87C196KT/87C196KS 20 MHz SPECIFICATION UPDATE

Release Date: January, 1997

Order Number: 272863-002

The 87C196KT/87C196KS 20 MHz may contain design defects or errors known as errata. Characterized errata that may cause the 87C196KT/87C196KS 20 MHz's behavior to deviate from published specifications are documented in this specification update.

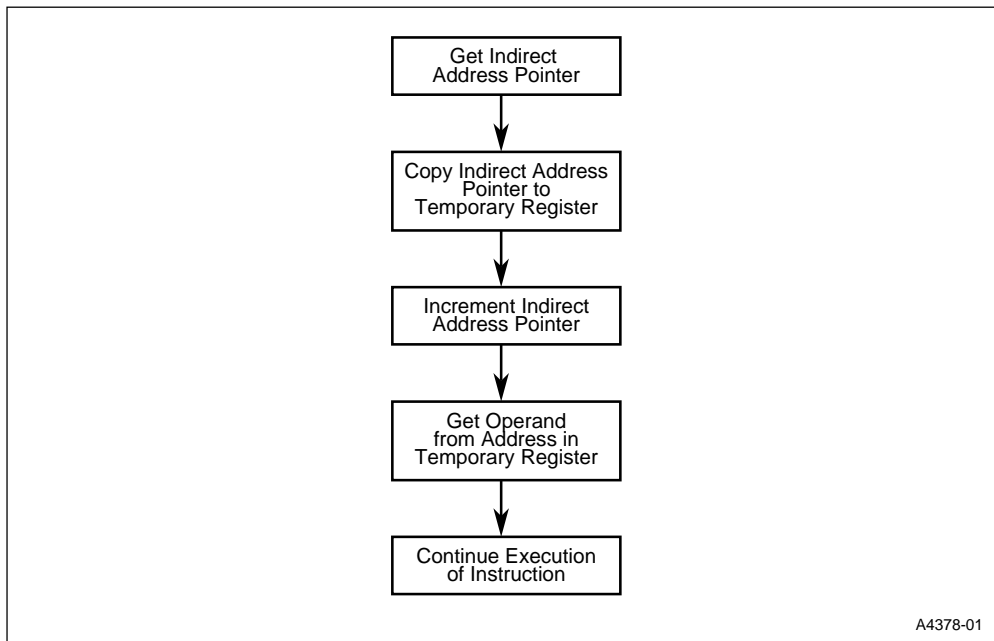
PROBLEM: The EPA can lock up if overruns are handled incorrectly. Overruns occur when an EPA input transitions at a rate that cannot be handled by the EPA interrupt service routine. If no overrun handling strategy is in place, and if the following three conditions exist, a situation may occur where both the capture buffer and the EPAX_TIME register contain data, and no EPA interrupt pending bit is set:

- an input signal with a frequency high enough to cause overruns is present on an enabled EPA pin, and
- the overwrite bit is set (EPAX_CON.0 = 1; old data is overwritten on overrun), and
- the EPAX_TIME register is read at the exact instant that the EPA recognizes the captured edge as valid.

The input frequency at which this occurs depends on the length of the interrupt service routine as well as other factors. Unless the interrupt service routine includes a check for overruns, this situation will remain the same until the device is reset or the EPAX_TIME register is read. The act of reading EPAX_TIME allows the buffered time value to be moved into EPAX_TIME. This clears the buffer and allows another event to be captured. Remember that the act of transferring the buffer contents to the EPAX_TIME register is what actually sets the EPAX interrupt pending bit and generates the interrupt.

WORKAROUND: Any one of the following methods can be used to prevent or recover from an EPA overrun situation.

- Clear EPAX_CON.0

When the overwrite bit (EPAX_CON.0) is zero and both the EPAX_TIME register and the capture buffer are full, the EPA does not consider a captured edge until the EPAX_TIME register is read and the data in the capture buffer is transferred to EPAX_TIME. This prevents overruns by ignoring new input capture events when both the capture buffer and EPAX_TIME contain valid capture times. The OVRx pending bit in EPA_PEND is set to indicate that an overrun occurred.

- Enable the OVRx interrupt and read the EPAx_TIME register within the ISR
If an overrun occurs, the overrun (OVRx) interrupt will be generated. The OVRx interrupt will then be acknowledged and its interrupt service routine will read the EPAx_TIME register. After the CPU reads the EPAx_TIME register, the buffered data moves from the buffer to the EPAx_TIME register. This sets the EPA interrupt pending bit.
- Check for pending EPAx interrupts before exiting an EPAx ISR
Another method for avoiding this situation is to check for pending EPA interrupts before exiting the EPA interrupt service routine. This is an easy way to detect overruns and additional interrupts. It can also save loop time by eliminating the latency necessary to service the pending interrupt. However, this method cannot be used with the peripheral transaction server (PTS).

Figure 1. 16-bit System with EPROM

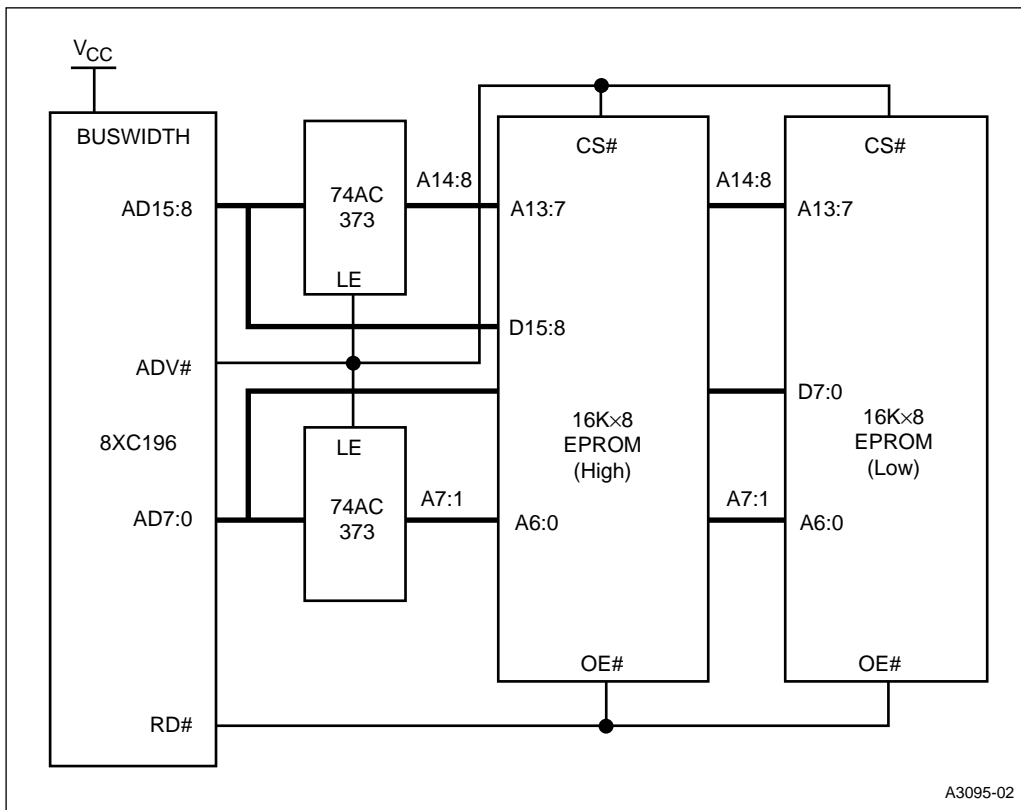
001. *High address inputs to the low EPROM should be A14:8 in Figure 15-18.*

ITEM: The next revision of the user's manual will include the following corrected graphic.
